MEMORANDUM

Re: Thomas Farms Subdivision – Preliminary Plat

THOMAS FARMS PRELIMINARY PLAT VILLAGE OF CALEDONIA

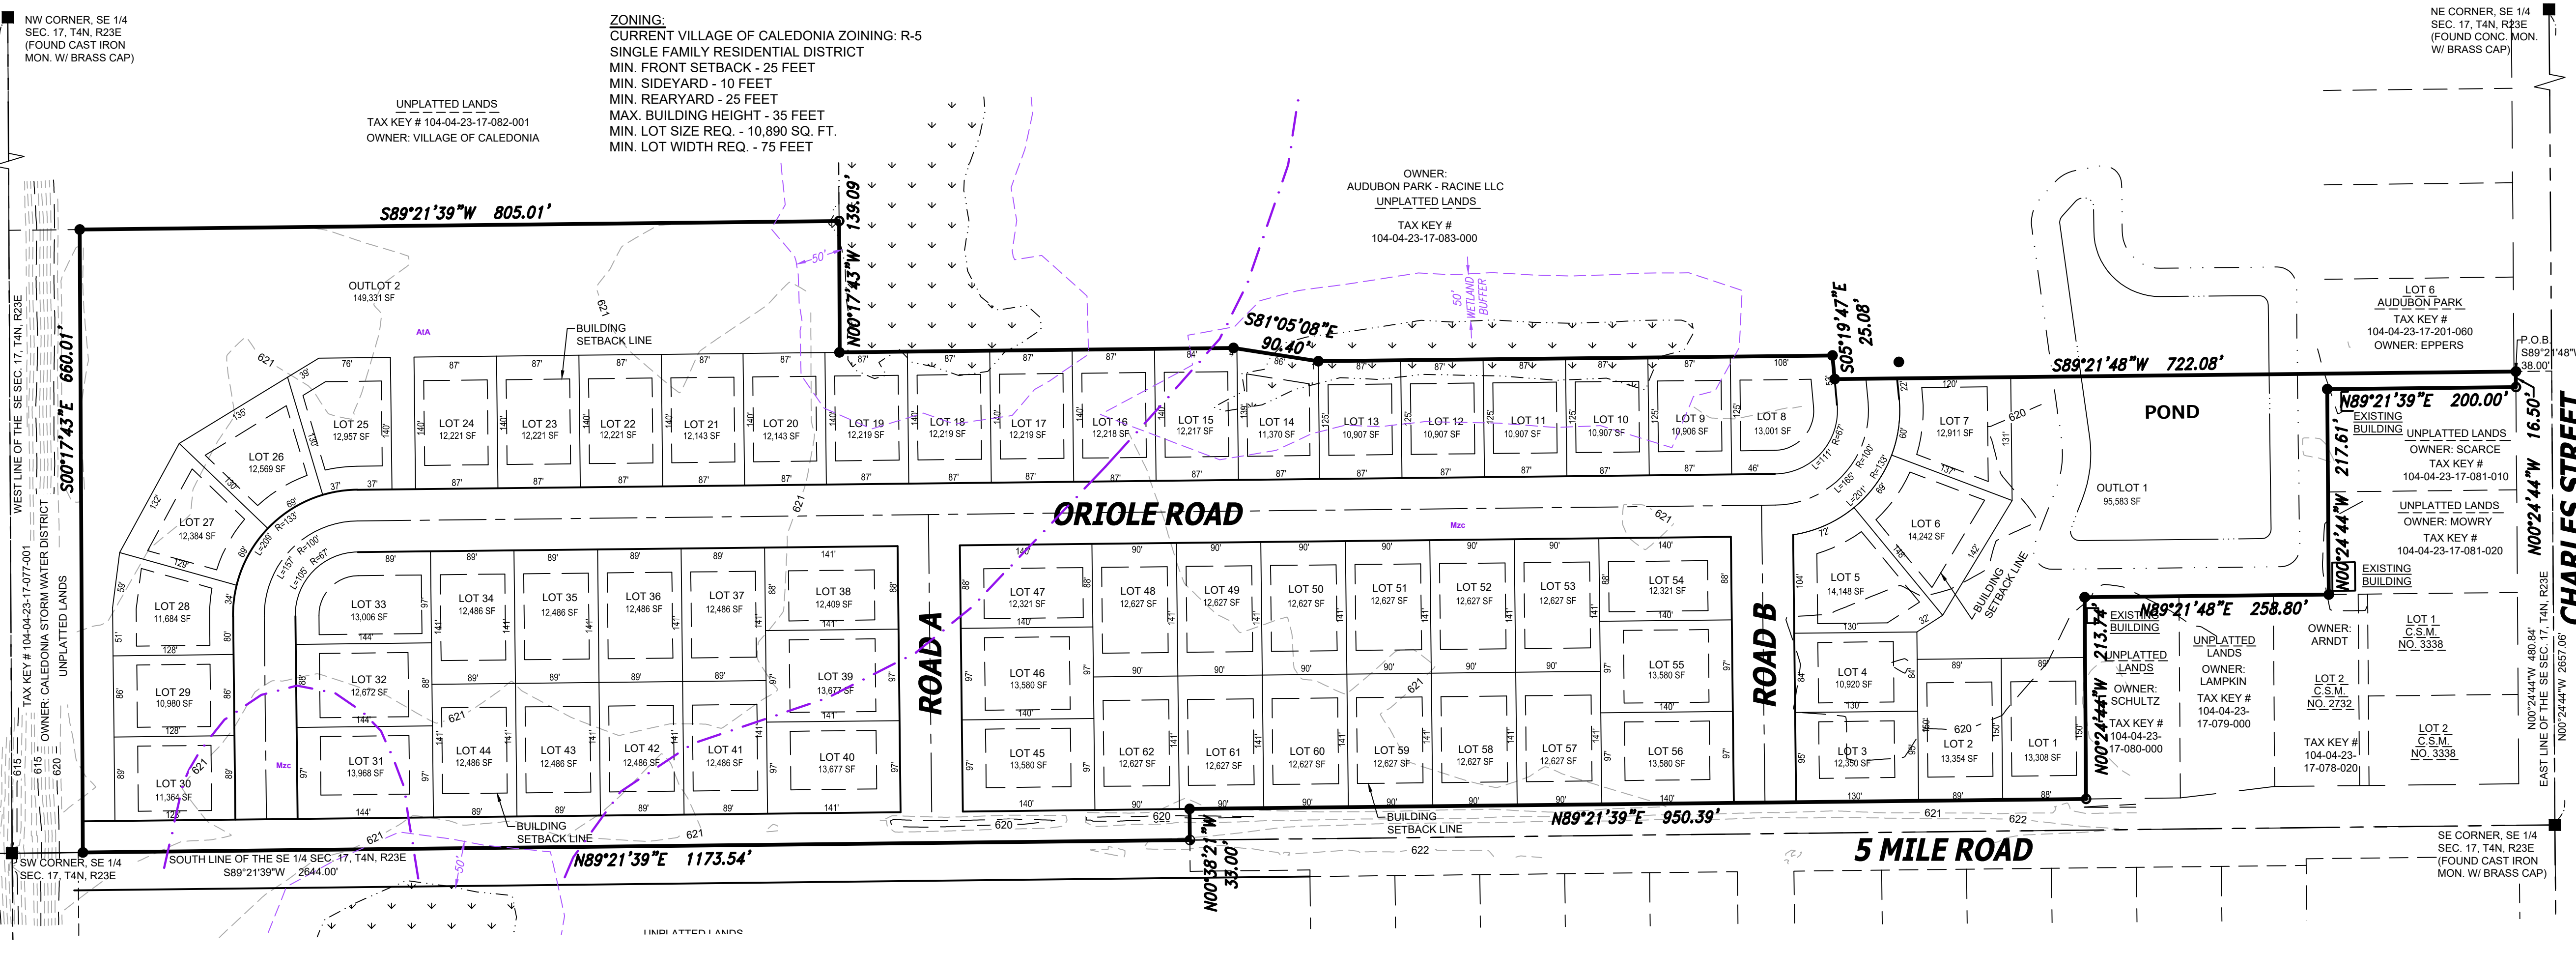
The proposed subdivision, as described above, is required to meet the R-5 Zoning District requirements. The major points of this zoning district are the minimum lot size of 10,890 sq. ft. and 75' of frontage. All the proposed lots meet and exceed these values. The smallest lot is 10,907 sq. ft. and the largest is 14,242 sq. ft. with frontages varying from 87-90 feet typically. The proposed density has not changed since the concept plan and meets and/or exceeds the required 3.64 units per acre. The density needs to be displayed on the Preliminary Plat per Ordinance requirements. There is a need to define and represent the shoreland zoning district from the navigable waterway (Klema Ditch). The 75' structural setback from the OHWM and the 300' shoreland zoning setback shall be placed on the Plat.

The subdivision was submitted with a set of preliminary engineering and storm water management plans. Staff will review these separately and provide feedback to the Design Engineer and Developer. The Preliminary Plat is missing information from name/ownership of lands 100' from the property and all easements (public/private), streets, widths, conditions, primary environmental corridors, etc. within 300' of the property. A phase 1 ESA is still required to be submitted on this property. The proposed Right-of-Way widths are missing and the proposed/required drainage easements and vision triangles. While it is listed on the Notes of the Preliminary Plat, all properties are restricted to 1 access each to the Village Road Network. Lots 3, 30, 31, 40, 45, and 56 will be limited to No Access along 5 Mile Road. This shall be shown on the Plat and a note provided. No Access shall also be included 50' from the corner of the Right-of-Way at each intersection along with the 25'x25' vision triangle. It is recommended to include these dimensions and other information in an updated version of the Preliminary Plat prior to the Village Board approval. Understandably, any easements may be modified upon completion of the civil/site design and shall ultimately be shown with the Final Plat.

Draft plans have been provided including estimated Finished Yard Grades of homes with potential lookouts/exposures. Due to the proximity of the Klema Ditch, all FYG's shall be a minimum of 2' above the High-Water Mark of the Klema Ditch. This shall be included in all Final Engineering/Utility Plans.

Per Title 14-3, the layout of proposed streets, walkways, and other improvements are to be shown on the Plat. It is recommended that the Developer provides the basic geometric outline for this data, including 5 Mile Road which should have a 40' flange to flange urban roadway and the proposed pedestrian trail along the east side of the Klema Ditch. By definition, a temporary turnaround tee will need to be provided at the north end of Oriole Road. This shall be done via temporary easement onto the abutting property to the north or onto Lots 7 and 8 per Village Ordinance Title 18. It is understood that future phases may make this negligible, but at this time, it is required until the future development occurs.

Roadway naming will need to be updated to reflect the extension of existing roads adjacent to the proposed subdivision. "Road A" shall be listed as Leawood Lane. "Road B" shall be listed as October Drive. The furthest west roadway that runs North and South shall be named North Meadows Drive and transition to the proposed Oriole Road at a point along the curve. This should be done to best plan for any future extension of the roads to the south of 5 Mile Road.

There is a legal description gap along the property line abutting the Village Owned land to the north. This shall be resolved upon submittal of the Final Plat. Lots 8-19 shall resolve the any lot line issue with the neighboring Audubon Arboretum Subdivision and abutting landowners as required. The future extension of 5 Mile Road will also require the acquisition of Right-of-Way to be dedicated to the public along the abutting property to the south. This will need to be done via CSM or other means of dedication and coordinated with the Village upon submittal of the Final Plat. There is also a permanent turnaround tee located on the north half of the existing 5 Mile Road that shall be shown and vacated as part of the Plat process.

As mentioned above, the preliminary civil/site/utility plans have been submitted to staff and will be reviewed separately. The property includes two storm water ponds; one in each Outlot. Easements will be required over the storm water ponds including the areas that are on abutting property. The Storm Water Management Plan shall be reviewed and approved by the Utility District along with final Civil/Utility Plans prior to or along with the Final Plat approval. This includes meeting the Village Ordinance requirements of Title 9 Chapter 2. The developer shall submit and get approvals for the extension of Sanitary Sewer and Watermain to the Wisconsin DNR and Racine Wastewater Utility.

A separate sanitary sewer utility easement is required for the proposed sewer and water main to connect at the current north end of North Meadows Drive. Current proposals show the water running west along 5 Mile Road across the Klema Ditch, which is a different pressure zone. This will not be acceptable and the watermain shall run south to North Meadows Drive through said easement and looped to that system. Staff are coordinating with the Developer and Owner to execute this easement agreement and ensure Village Standards are maintained.

A wetland delineation was performed in 2022 and included both the Audubon Arboretum and the proposed subdivision. They are shown on the Preliminary Plat as required and a copy is on file with the Village. The proposed subdivision does show the encroachment of some wetlands on the buildable footprint of Lots 9-19. It is recommended that these are resolved via exemption or other means and evidence is provided to the Village upon the Final Plat submittal. The proposed 50' wetland buffer for impervious surface drainage will impact these same lots and will require the Developer to account for in the Civil/Site Design.

7. The Developer shows the 75' and 300' shoreland setbacks from the Klema Ditch OHWM.
8. The Developer executes and provides the necessary Utility Easements on abutting Thomas Plantation property.

9. The Developer and their Engineer ensures that the proposed water main for this system is looped south into North Meadows Drive through the proposed Utility Easement.

11. The Developer resolves the gap in legal descriptions along the Village Owned Parcel.
12. The Developer shows the existing turnaround tee on 5 Mile and vacates this as part of the Plat Process.

13. The Developer shows the 25'x25' Vision Triangle Easements at all intersections prior to Village Board approval.
14. The Developer places No Access Restrictions on Lots 3, 30-31,40,45, and 56 along 5 Mile Road and for 50' at each intersection corner prior to Village Board approval.

15. The Developer shall resolve the wetland encroachment onto Lots 8-19 via exemption or other means to ensure the buildable footprint of the lot is unaffected and provide evidence to the Village.

16. The Developer corrects the roadway names as described above to account for the existing road network to the south prior to Village Board approval.
17. The Developer provides for a temporary turnaround tee at the end of Oriole Road until a future development occurs per Ordinance Title 18.

18. The Developer and their Engineer ensures all FYG's are a minimum of 2' above the High Water Mark of the Klema Ditch.
19. The Developer shows the required 100' and 300' radius of information for the Preliminary Plat prior to Village Board Approval.

20. The Developer shows the proposed drainage and utility easements as required on the Preliminary Plat prior to Village Board approval.
21. Prior to any construction or earthmoving activities, the Developer or his/her Contractor shall obtain a Land Disturbance Permit with the Village and DNR.
